referred to in the  
**APPROVAL**

**AMENDED IN RED**

# SITE BASED STORMWATER MANAGEMENT PLAN

Proposed Development at  
8 REDHEAD STREET, DOOLANDELLA  
for  
AUSBUILD GROUP PTY LTD

**TYPICAL SECTION - TYPE B**  
**CONCRETE SLEEPER/UB POST RETAINING WALL**  
 SCALE 1:20

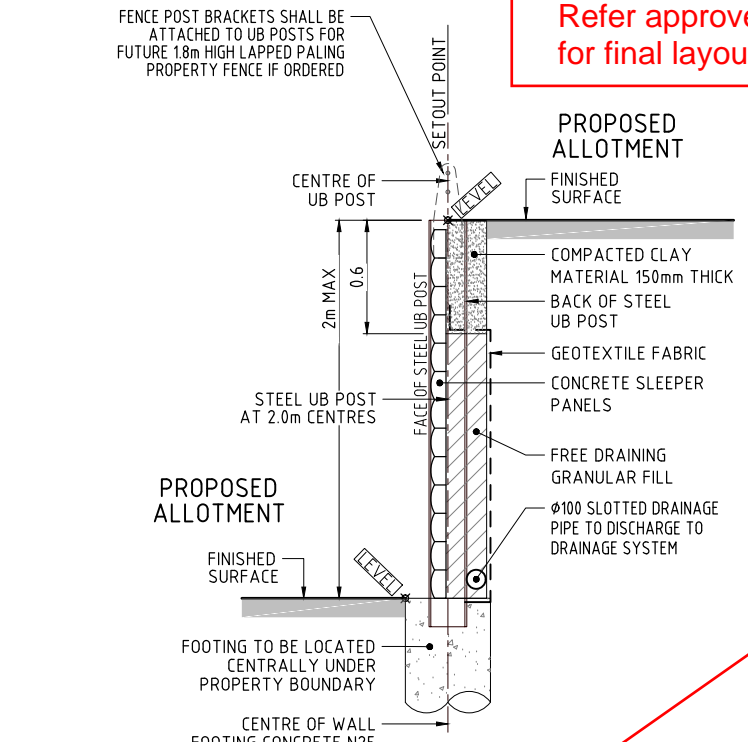
**SUPERSEDED**

**AMENDED IN RED**  
 22/05/2026

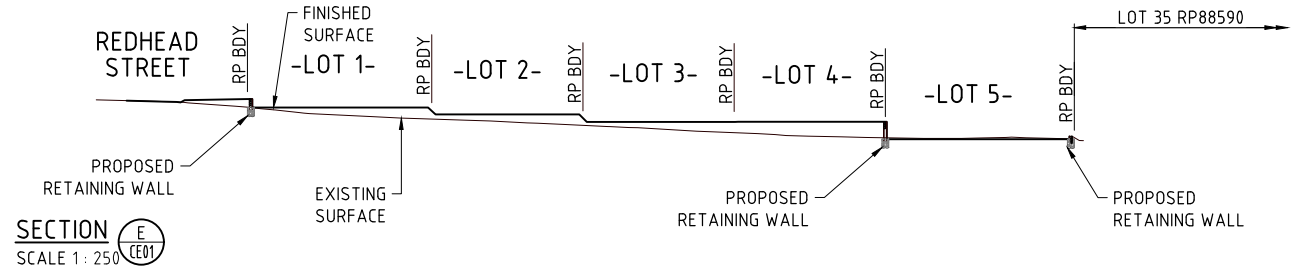
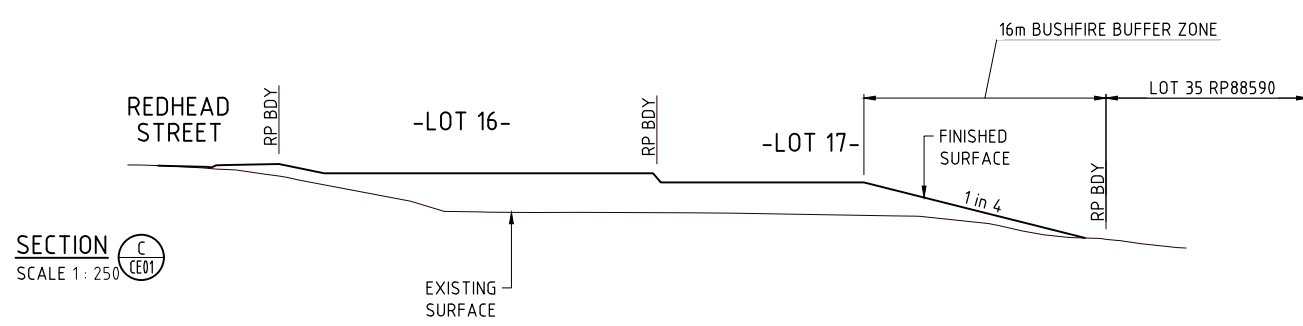
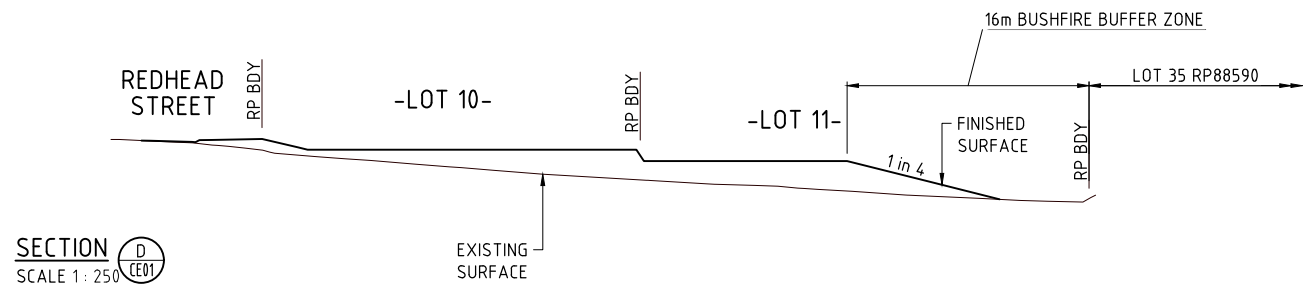
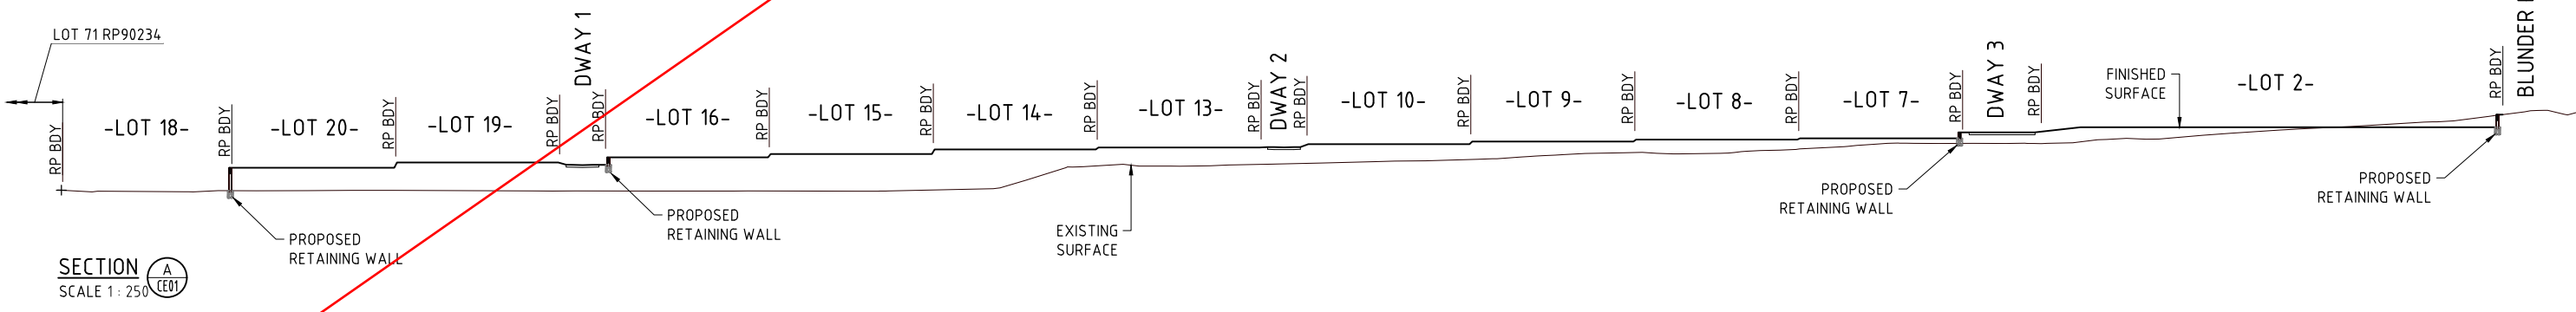
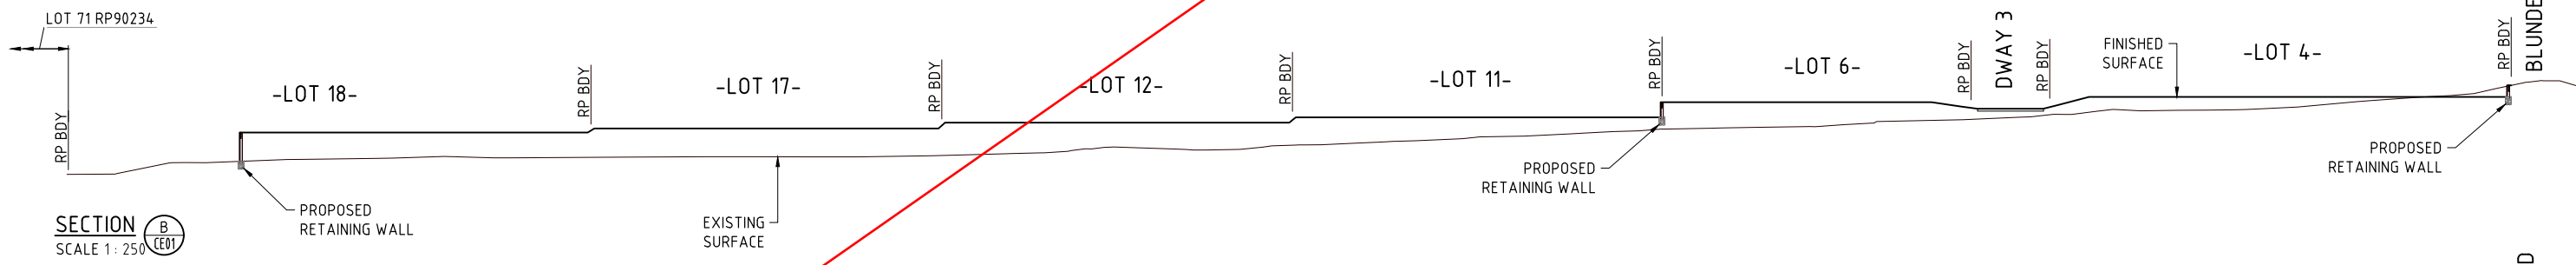
BRISBANE CITY COUNCIL  
AMENDED IN RED  
22/05/2026

SUPERSEDED
